Subject: DOE Review of the NRC Draft Generic Technical Position On  
In Situ Testing During Site Characterization for High-Level  
Nuclear Waste Repositories

REVIEW: NRC DRAFT GENERIC TECHNICAL POSITION ON  
IN SITU TESTING DURING SITE CHARACTERIZATION  
FOR HIGH-LEVEL NUCLEAR WASTE REPOSITORIES  
March 28, 1985

U. S. NUCLEAR REGULATORY COMMISSION  
DRAFT GENERIC TECHNICAL POSITION ON  
IN SITU TESTING  
DURING SITE CHARACTERIZATION  
FOR HIGH-LEVEL NUCLEAR WASTE REPOSITORIES

Figure 1 A SCHEMATIC OF SITE ACTIVITIES AND/OR TESTING MILESTONES

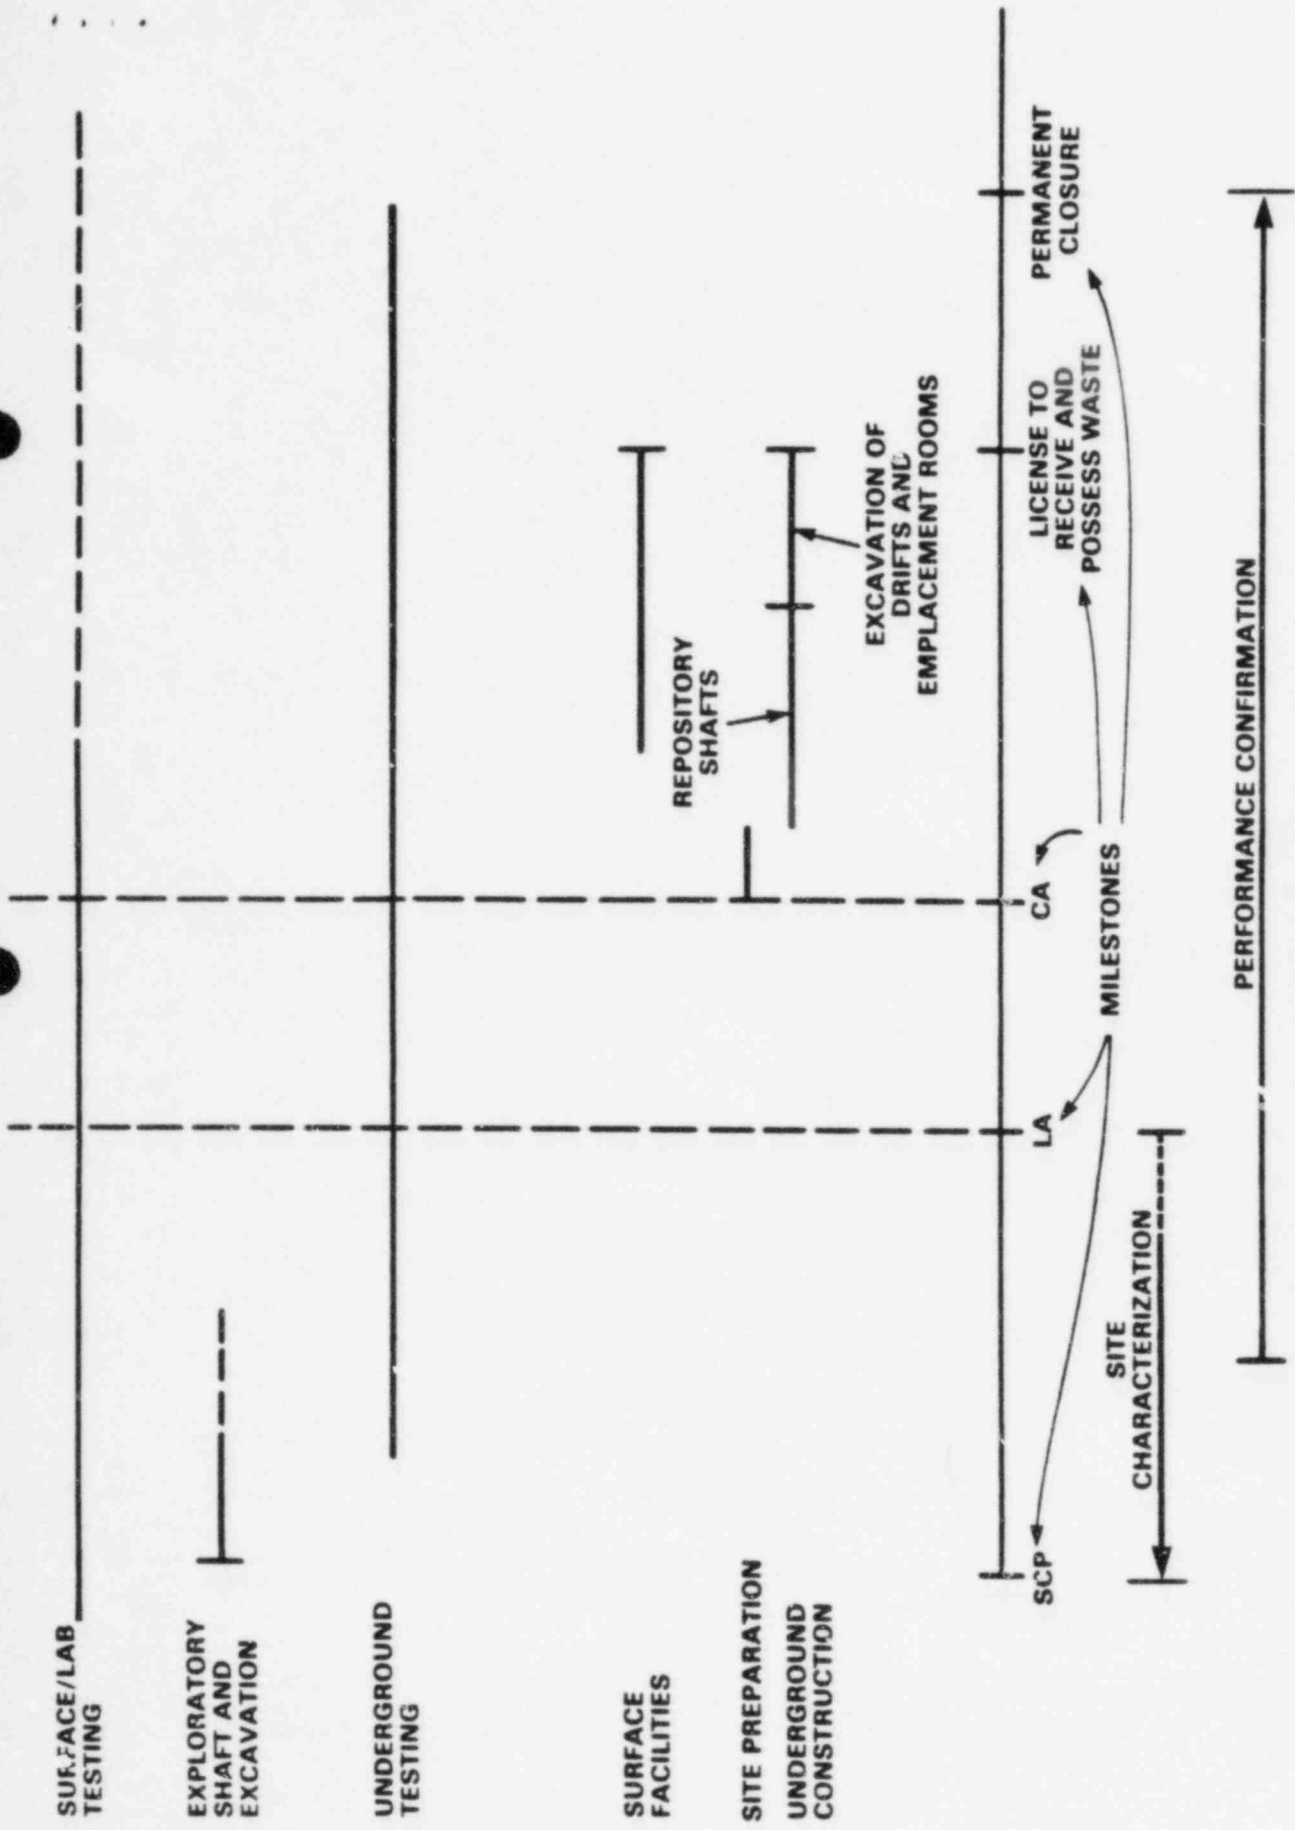
Figure 1

This figure appears to indicate that excavation of drifts and emplacement rooms will be completed at the time the license to receive and possess is issued. This is not necessarily the case and the figure should be revised accordingly.

**Figure 2 REDUCTION OF UNCERTAINTIES ABOUT COMPLIANCE WITH 10CFR60 PERFORMANCE REQUIREMENTS**

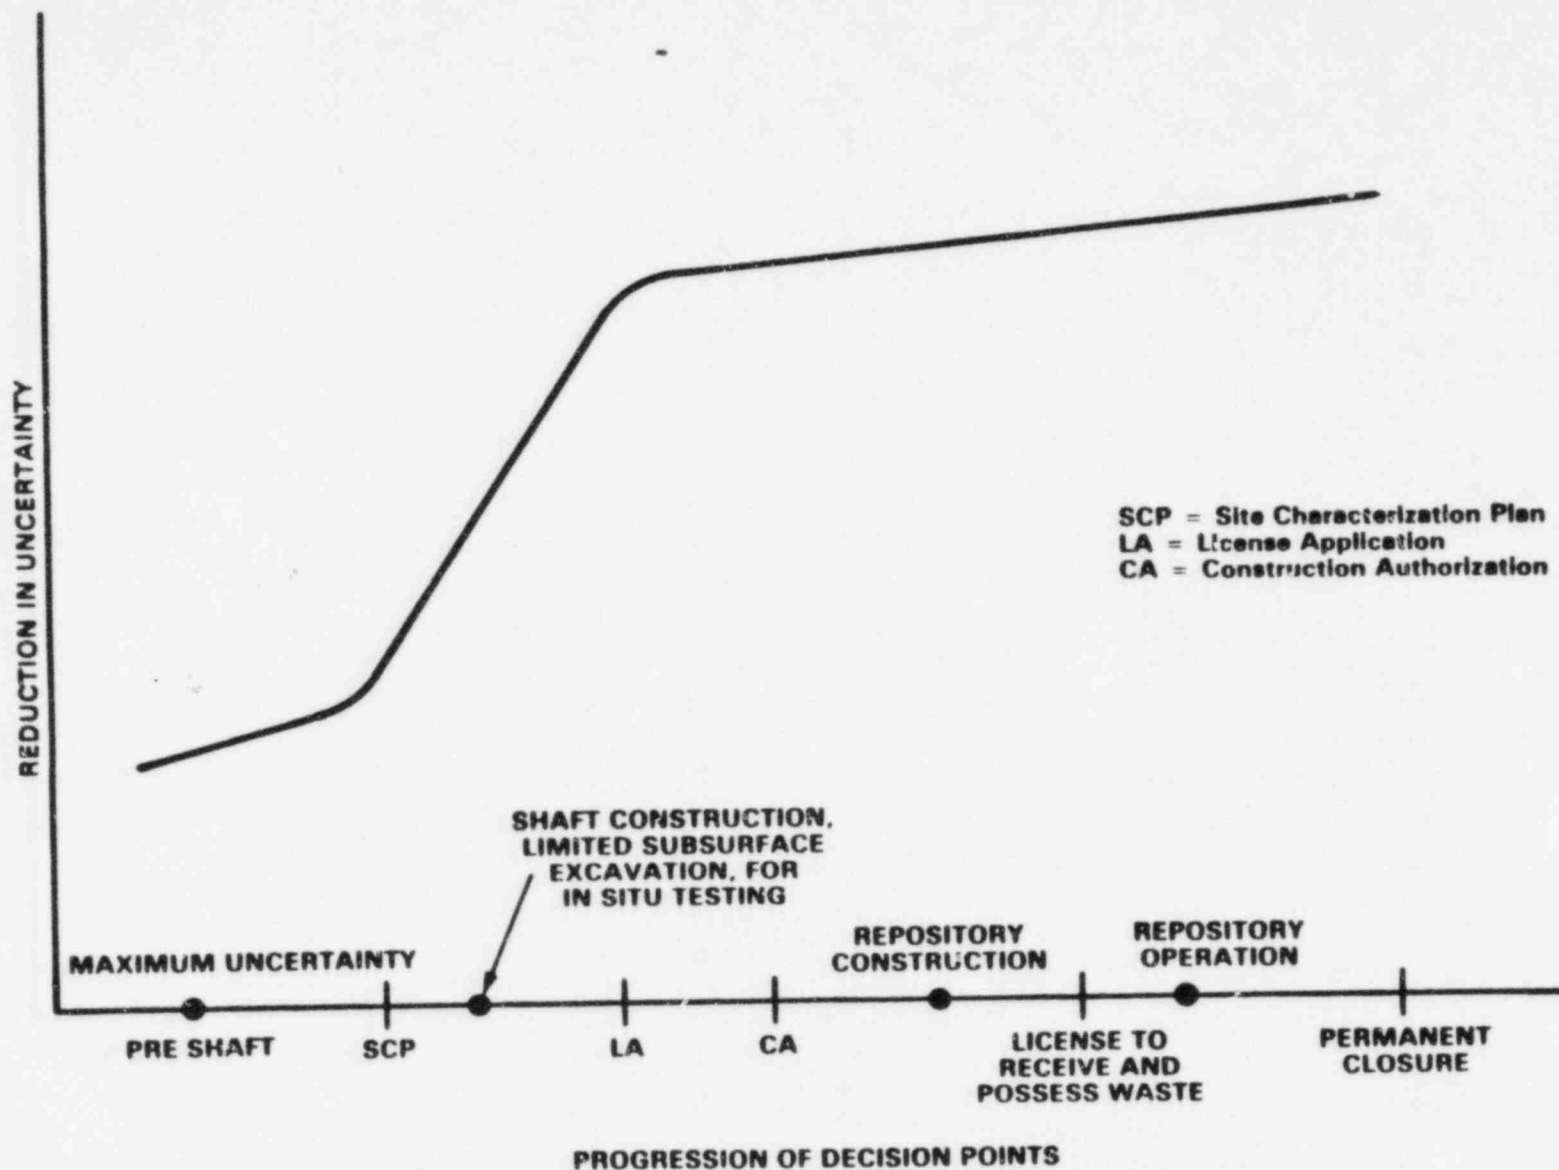
Section 3.0, Paragraph 1 and Figure 2

The maximum uncertainty precedes the various types of testing performed to select sites for characterization. Considerable uncertainty has already been removed, as documented in the draft EA's. NRC's expectation as to the amount of uncertainty reduction during underground testing alone is over-simplified and optimistic. Other site characterization activities and follow-on testing programs will be required to further reduce this uncertainty and ensure the representativeness of the initial testing to the entire repository.
